Refer to: HSA-10/LS-53

Thank you for your letter of May 1, 2002, requesting Federal Highway Administration (FHWA) acceptance of a modification to your company's TS-1000 Threaded Traffic Signal Pedestal Base and TS-1000 Modified Threaded Traffic Signal Pedestal Base as breakaway bases for use on the National Highway System (NHS). Accompanying your letter were drawings of the original and modified bases. You requested that we find the modifications to these bases acceptable for use on the NHS under the provisions of National Cooperative Highway Research Program (NCHRP) Report 350 "Recommended Procedures for the Safety Performance Evaluation of Highway Features."

TS-1000-L
TOP & DOOR
 JOB #2327 JOB #8698

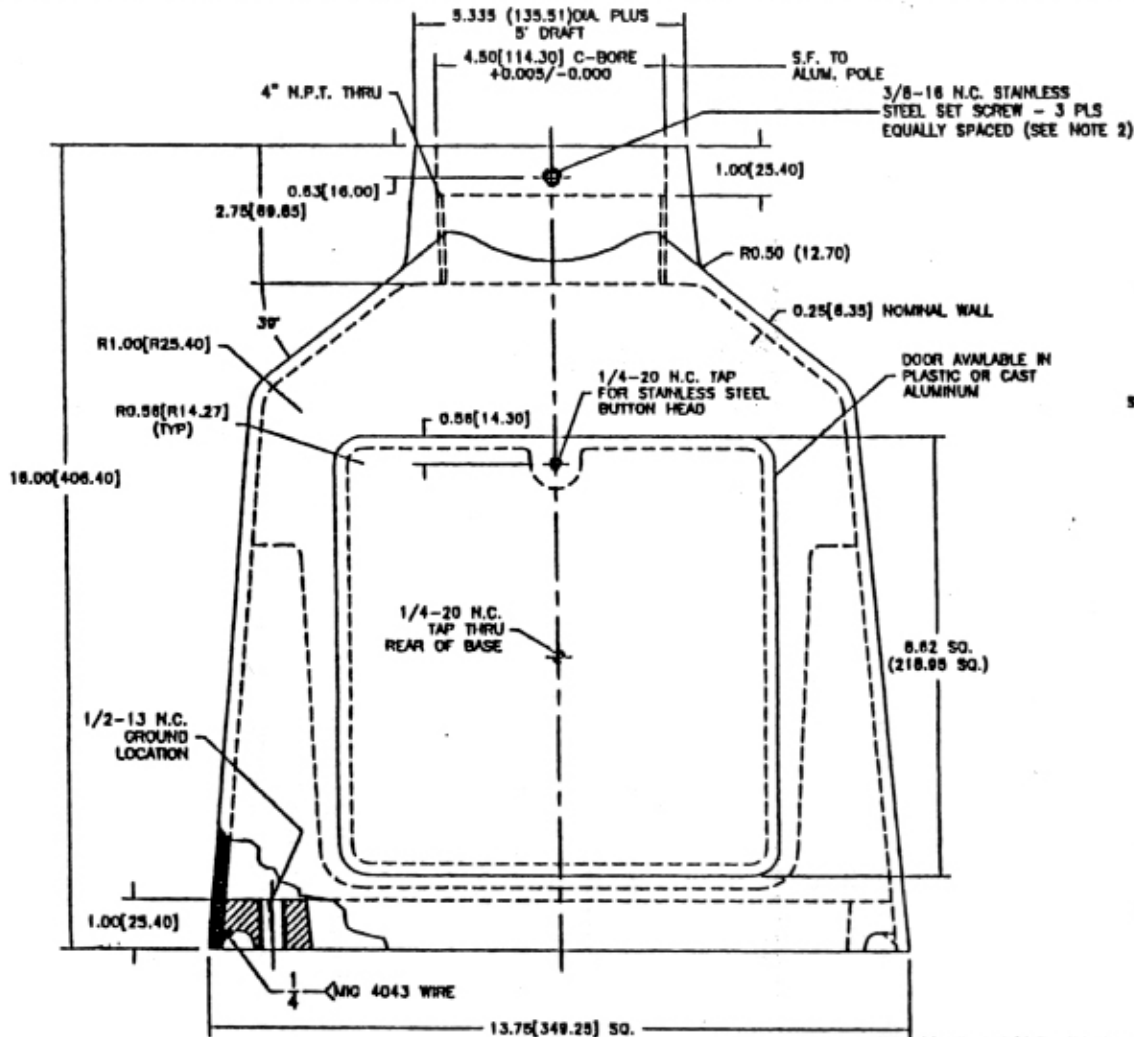
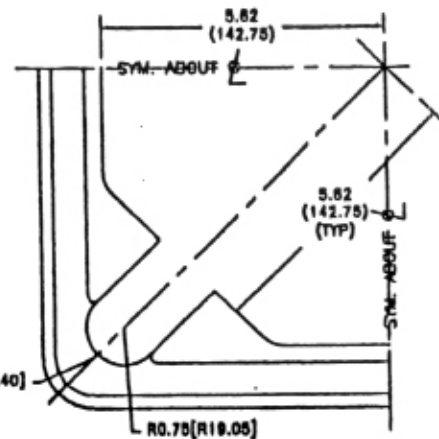
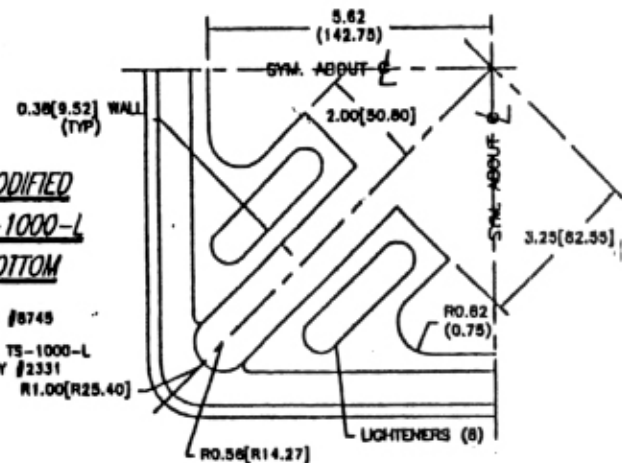
Full-scale automobile testing was conducted on the TS-1000 bases, and they were accepted in our November 19, 1997, letter LS-47. The proposed change to the bases involves adding a collar to the top to provide a more secure anchorage for the pole that is threaded into the top of the base. Because these bases' crash performance is by virtue of their breaking at the bottom, the addition of the collar and/or gussets at the top should have no adverse affect on their breakaway performance.

Because the performance of the subject bases modified with the collar (designated TS-1000-L) and/or gussets (designated TS-1000-L With Gussets) is expected to be similar to the crash tested bases, the devices described above and shown in the enclosed drawings for reference are acceptable for use as Test Level 3 devices on the NHS under the range of conditions tested, when proposed by a State.
